<b>Title - Sujet</b> Health Care Expansion	
<b>Solicitation No. - N° de l'invitation</b> EZ899-181607/A	<b>Amendment No. - N° modif.</b> 005
<b>Client Reference No. - N° de référence du client</b>	<b>Date</b> 2017-12-15
<b>GETS Reference No. - N° de référence de SEAG</b> PW-\$PWY-025-8228	
<b>File No. - N° de dossier</b> PWY-7-40258 (025)	<b>CCC No./N° CCC - FMS No./N° VME</b>
<b>Solicitation Closes - L'invitation prend fin</b> <b>at - à 02:00 PM</b> <b>on - le 2017-12-22</b>	<b>Time Zone</b> <b>Fuseau horaire</b> Pacific Standard Time PST
<b>F.O.B. - F.A.B.</b> <b>Plant-Usine:</b> <input type="checkbox"/> <b>Destination:</b> <input checked="" type="checkbox"/> <b>Other-Autre:</b> <input type="checkbox"/>	
<b>Address Enquiries to: - Adresser toutes questions à:</b> Fung, Donna(PWY)	<b>Buyer Id - Id de l'acheteur</b> pwy025
<b>Telephone No. - N° de téléphone</b> (604) 671-9689 ( )	<b>FAX No. - N° de FAX</b> (604) 775-6633

This Amendment No. 005 is raised to:

Healthcare Expansion  
Mountain Institution, Agassiz, BC

The following changes in the tender documents are effective immediately. This addendum will form part of the contract documents.

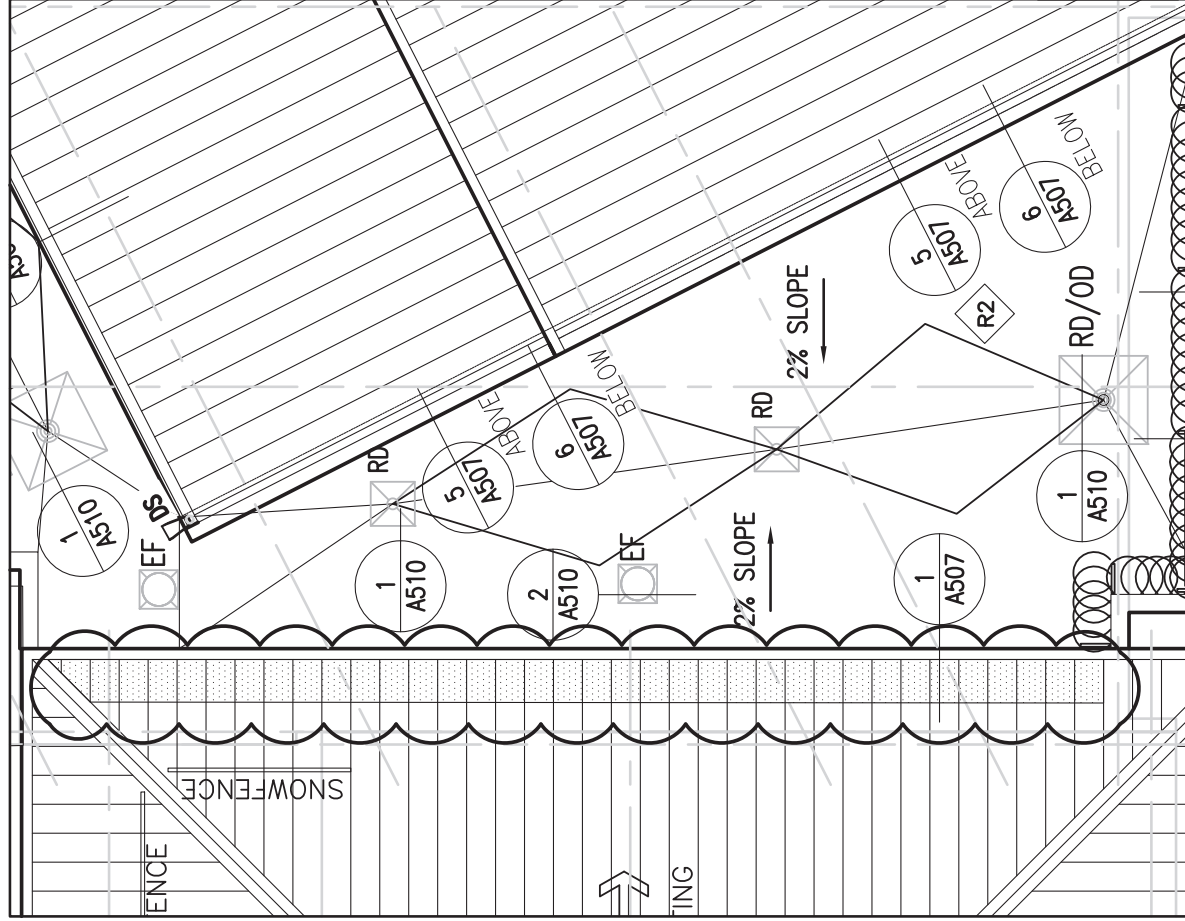
7. Question: Please provide the information for the following items. Modified bituminous waterproofing is shown only for wall between crawl space and Slab on grade wall. If other basement walls will not be applied with bituminous waterproofing.

- Answer: See ASK-01 issued in Addendum #02 for full extent of waterproofing. Provide protection board for all waterproofing. Where waterproofing occurs not under a slab, step down waterproofing to maintain adequate coverage by grade per manufacturer's recommendations.

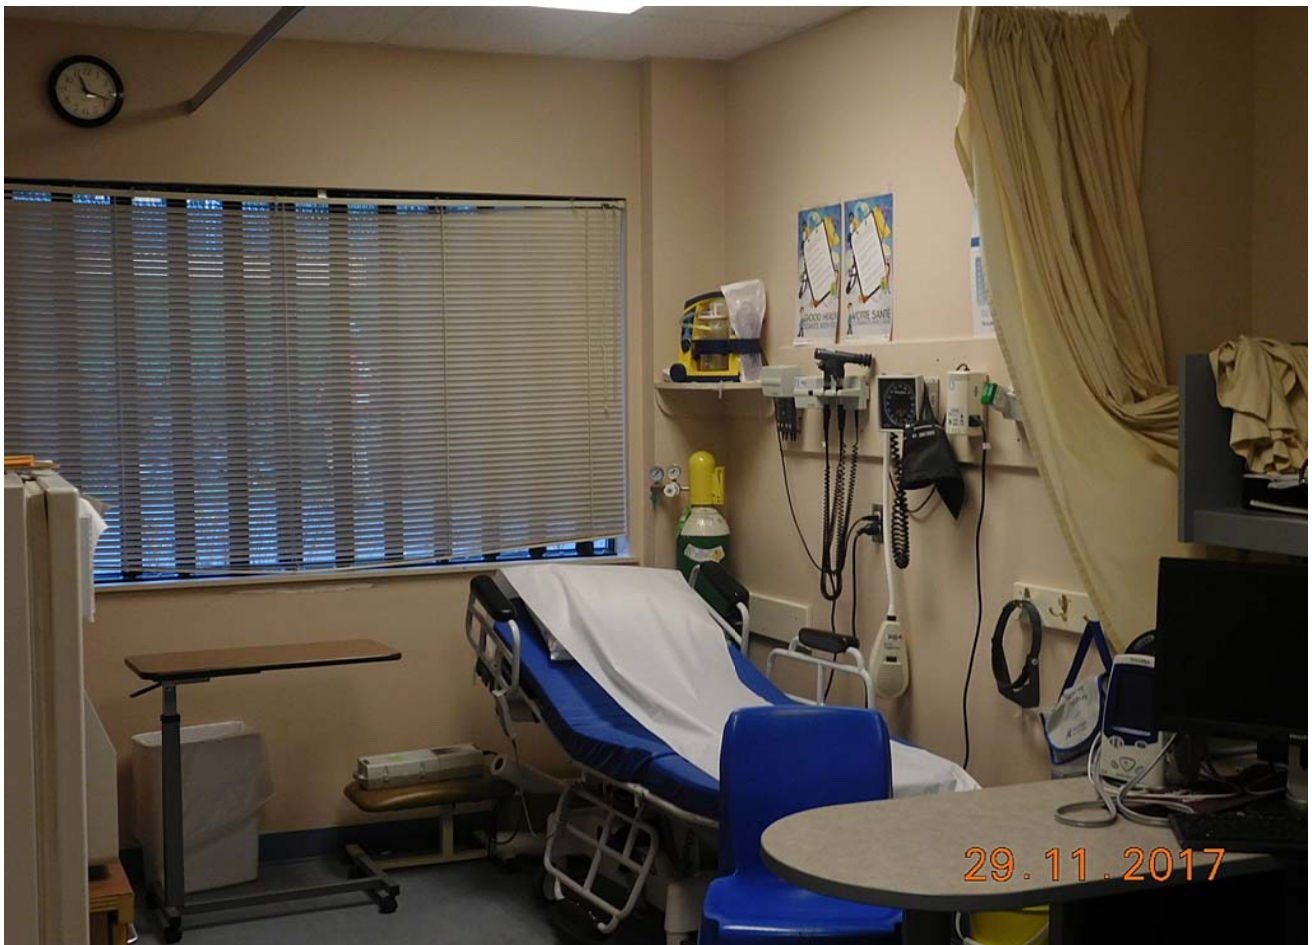
- .1 A110 ROOF PLAN
  - a) **[Revise]** Roof plan per bubbled area on ASK-02
- .2 A507 SECTION DETAILS 1
  - a) **[Replace]** Detail 01/A507 with ASK-03, complete.

CUT BACK EXISTING METAL ROOF, MODIFY  
EXISTING ROOF ASSEMBLY, SEE DETAIL 1/A507
